To: T10 Technical Committee
From: Amr Wassal, PMC-Sierra (amr_wassal@pmc-sierra.com)
Stephen Finch, STMicroelectronics (steve.finch@st.com)
Date: 16 November 2006
Subject: 06-515r0 (formerly 06-324) SAS-2 Modifications to the SAS Speed Negotiation

Figure 131— SP (phy layer) state machine - SAS speed negotiation states

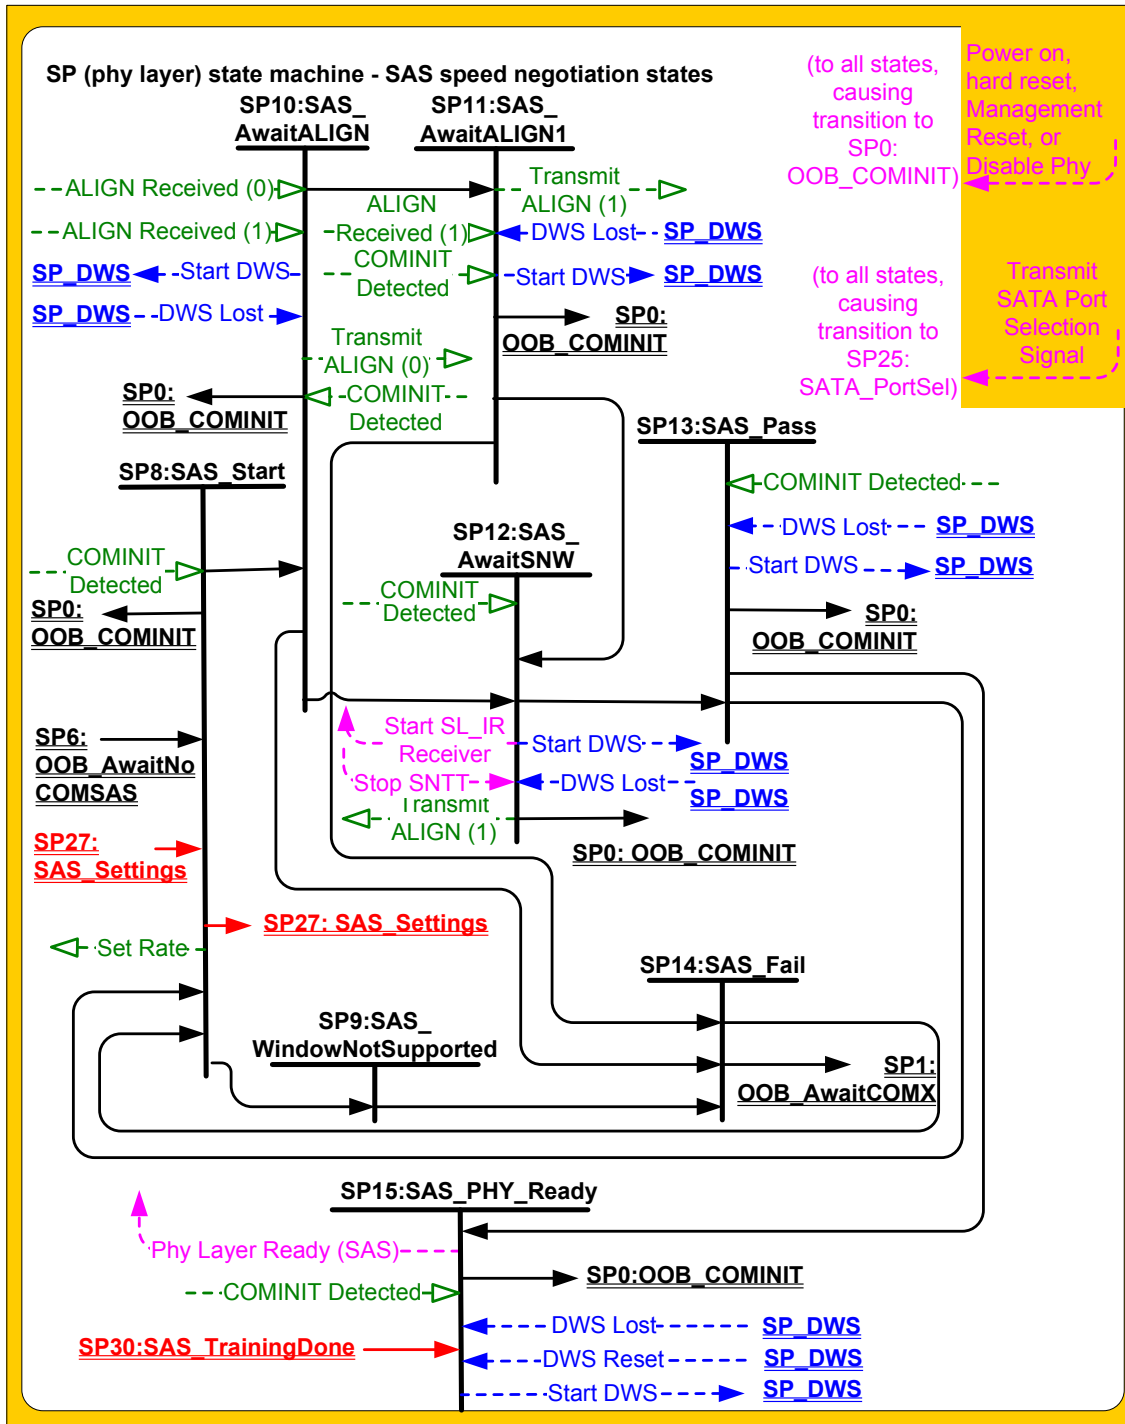
Changes to Figure 132 are in RED and Underlined in the figure. The associated transition arrows are also added in RED.

Figure 132 — SP (phy layer) state machine - SAS speed negotiation states related to SNW-3 and Final-SNW

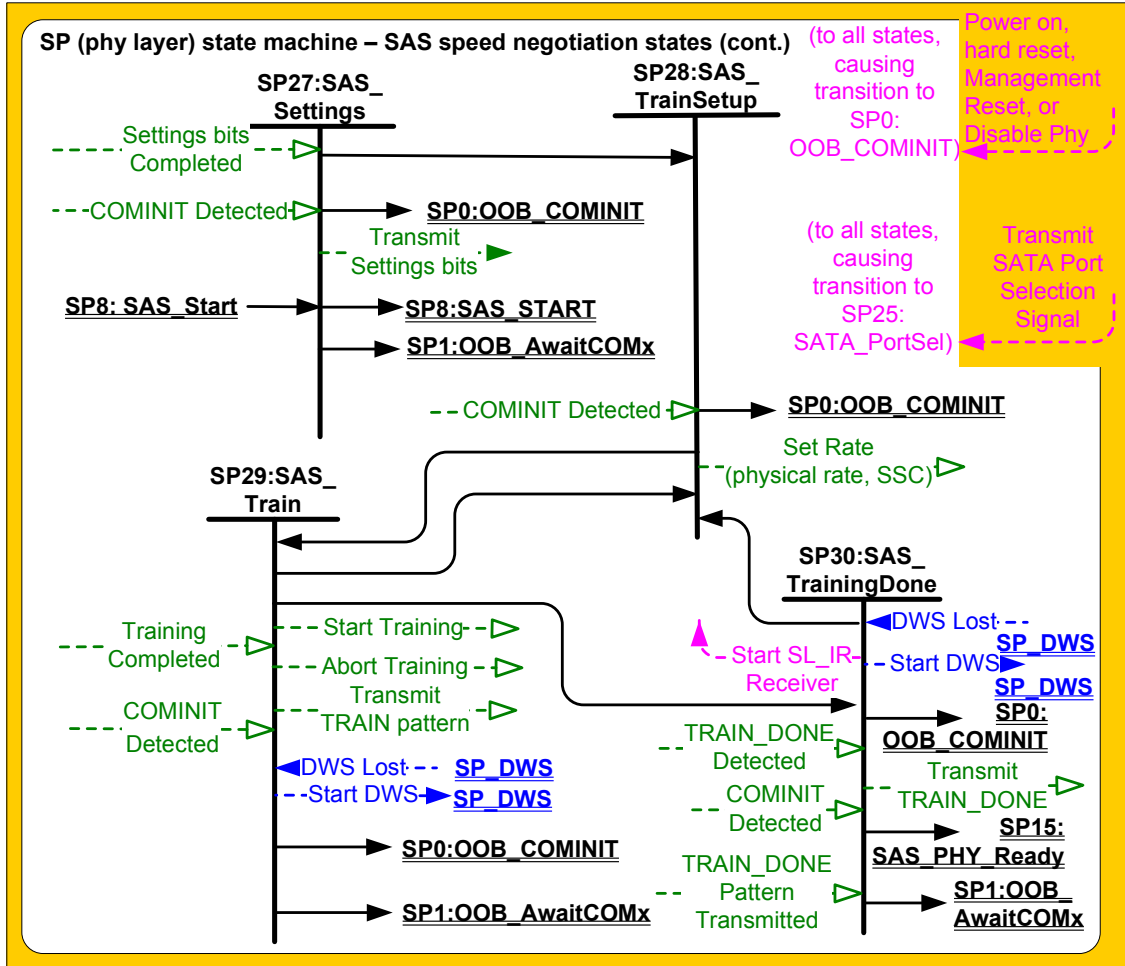
Figure 132 shows the SAS speed negotiation states related to SNW-3 and the Train-SNW speed negotiation windows.

Figure 132 is a completely new figure.
